CITY OF ALBUQUERQUE

Re: **Sonic Drive-In**
~~Project Address~~ 6420 Central Ave SW
Traffic Circulation Layout
Architect's Stamp 6-2-17 (K11D047)
3/14/18

The TCL submittal received 04-04-18 is approved for Building Permit. A copy of the stamped and signed plan will be needed for each of the building permit plans. Please keep the original to be used for certification of the site for final C.O. for Transportation.

SITE PLAN, DESIGN DATA
AND NOTES

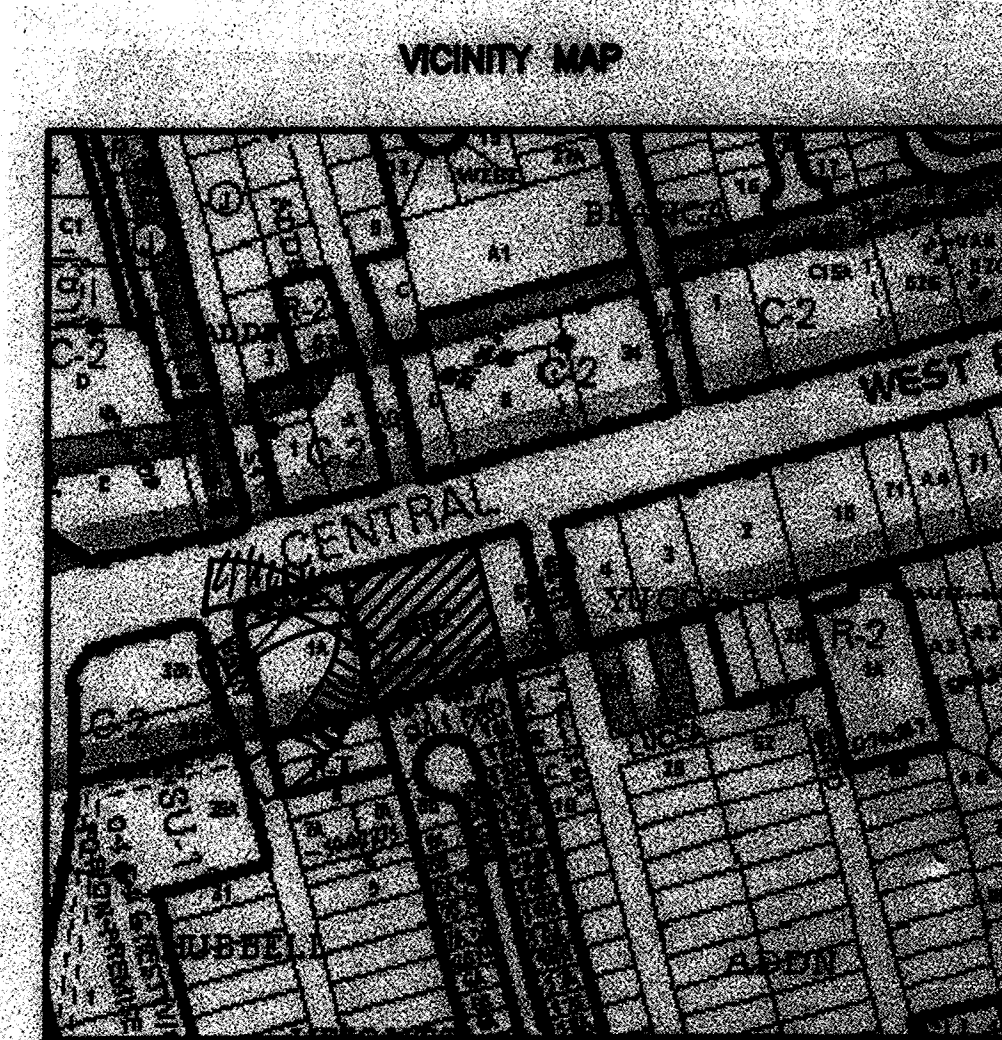
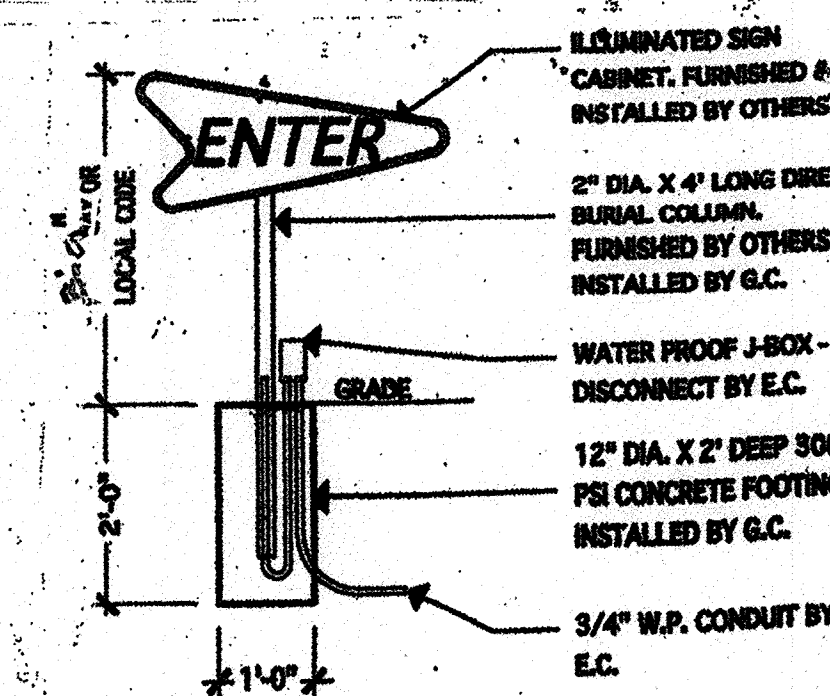
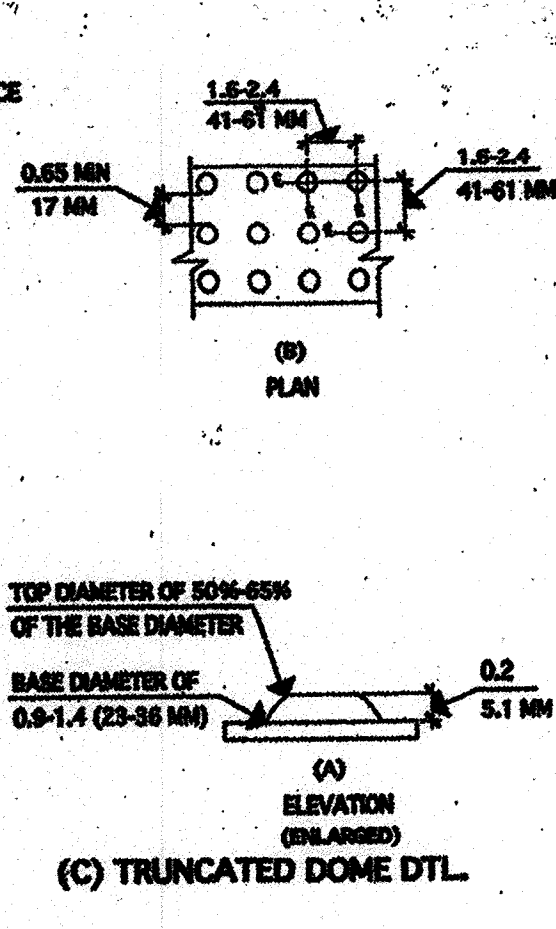
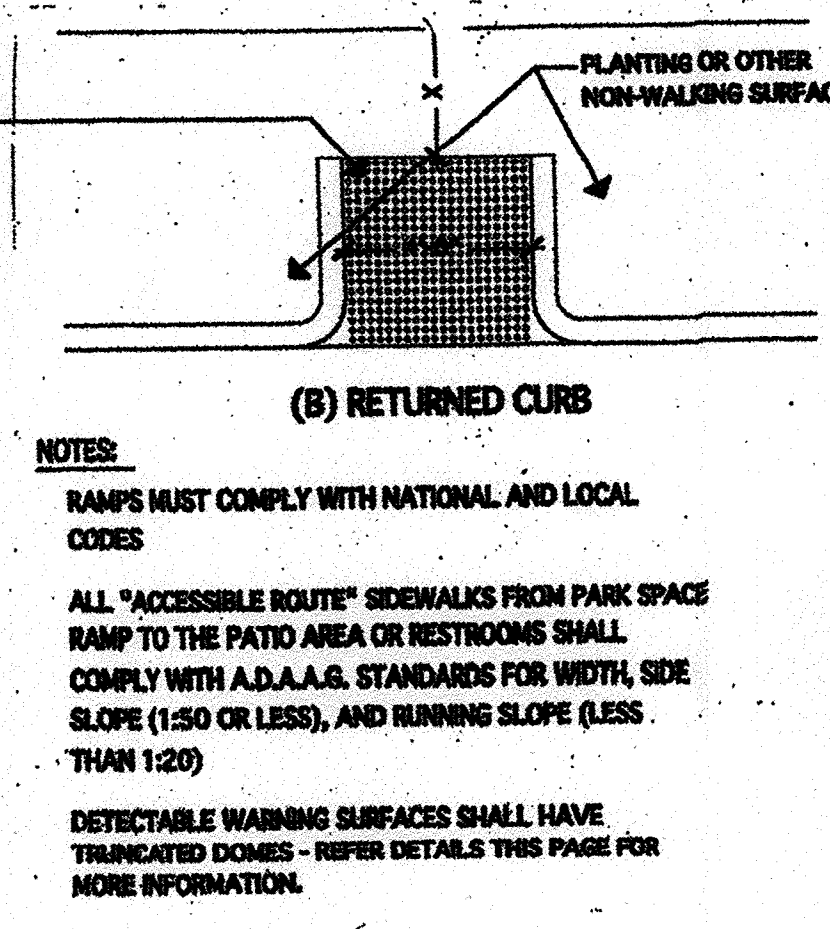
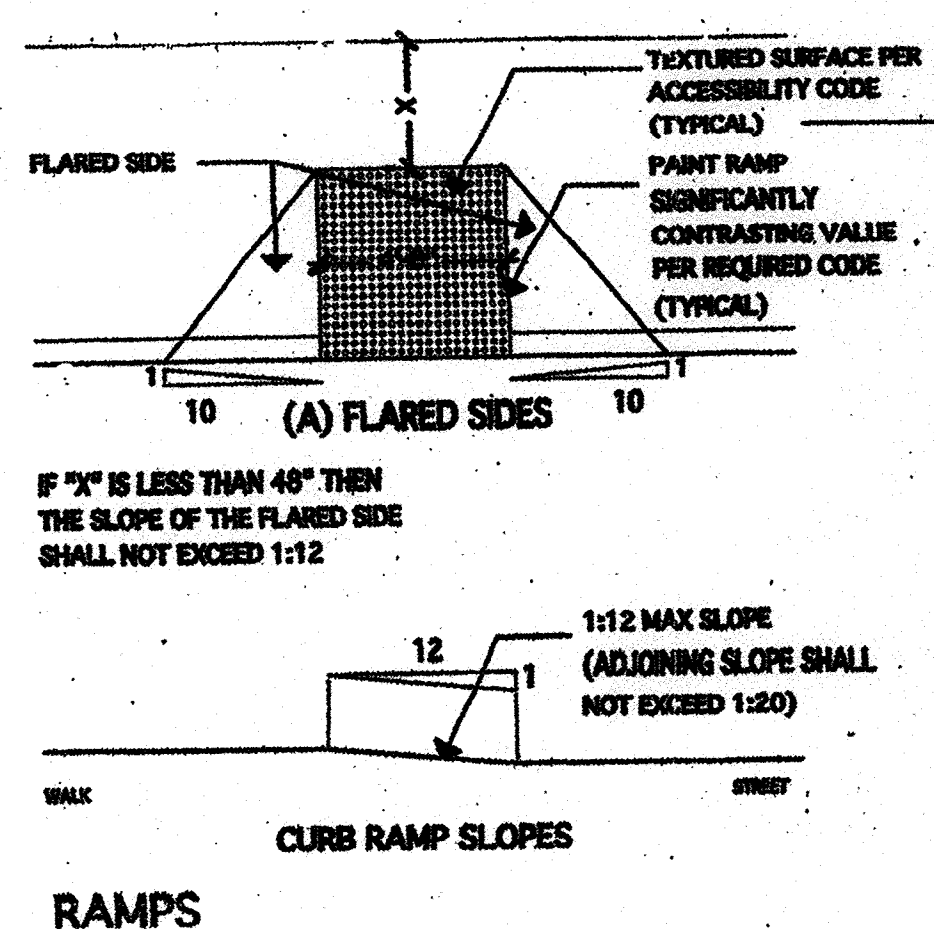
The ADA accessible parking sign must have the required language per 66-7-352.4C NMSA 1978 "Violators Are Subject to a Fine and/or Towing." Please call out detail and location of HC signs.

The ADA access aisles shall have the words "NO PARKING" in capital letters, each of which shall be at least one foot high and at least two inches wide, placed at the rear of the parking space so as to be close to where an adjacent vehicle's rear tire would be placed. (66-1-4.1.B NMSA 1978)

Motorcycle parking spaces shall be designated by its own conspicuously posted upright sign, either free-standing or wall mounted per the zoning code.

Per the zoning code, a 6 ft. wide ADA accessible pedestrian pathway is required from the public sidewalk to the building entrances. Please clearly show this pathway and provide details.
